SEQUOYAH NUCLEAR PLANT (SQN) - REVISED RESPONSES TO NRC QUESTIONS 1, 2, and 3 FOR TECHNICAL SPECIFICATION (TS) CHANGE 00-14, "PRESSURE TEMPERATURE LIMITS REPORT (PTLR) AND REVISED TOPICAL REPORT (WCAP-15984, REVISION 1), REACTOR CLOSURE HEAD/VESSEL FLANGE REQUIREMENTS EVALUATION FOR SEQUOYAH UNITS 1 AND 2" (TAC NOS. MB6436 AND MB6437)

SEQUOYAH NUCLEAR PLANT (SQN) REVISED RESPONSES TO NRC QUESTIONS 1, 2, AND 3

TECHNICAL SPECIFICATION (TS) CHANGE NO. 00-14, DOCKET NOS. 50-327 AND 50-328

Figure 1-1 Finite Element Model for Closure Head Region, Sequoyah Units 1 and 2

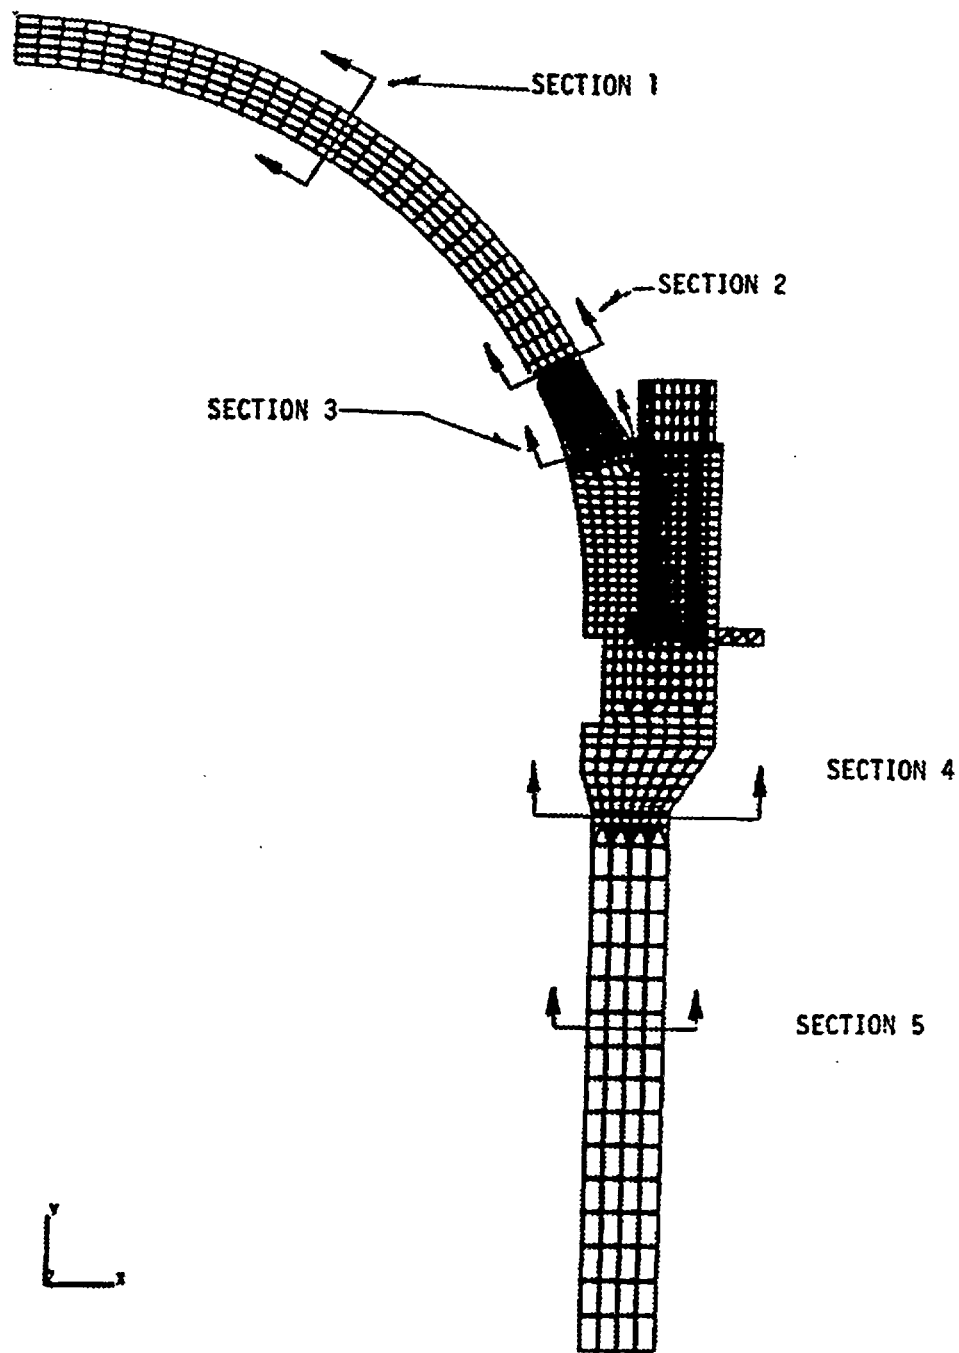
Regarding the discussion on page 4-1, "These results [the stresses for boltup and steady-state operation given in Table 4-1] were taken from a finite element analysis of the heatup/cooldown process, and the boltup was determined to be the most limiting time step for the entire heatup/cooldown transient."

Provide a summary which identifies how the finite element analysis (FEA) was performed, including important analysis variables (e.g., mesh size/element used, convergence criteria, thermal transient time step magnitude, boundary conditions, etc.). The level of detail provided should be such that the U.S. Nuclear Regulatory Commission (NRC) staff will have reasonable assurance regarding the acceptability of the licensee's FEA process and input variables. Provide stress analysis results consistent with the level of detail provided in Table 4-1) and through wall temperature distributions at twenty evenly distributed points along the most limiting heatup/cooldown transient which was analyzed.

The stress analysis was performed using an axisymmetric model shown in the cross section in Figure 1-1, where the cross section of interest is highlighted as Section 3.

Choosing to couple mechanically at only the pivot location, as discussed above, should tend to increase the bending stresses at all the selected Sections 1 through 5 shown on Figure 1-1. Mechanical coupling at more than one node, or all the nodes on the flange mating surface would have prevented free rotation of the flanges and reduced the bending stresses.
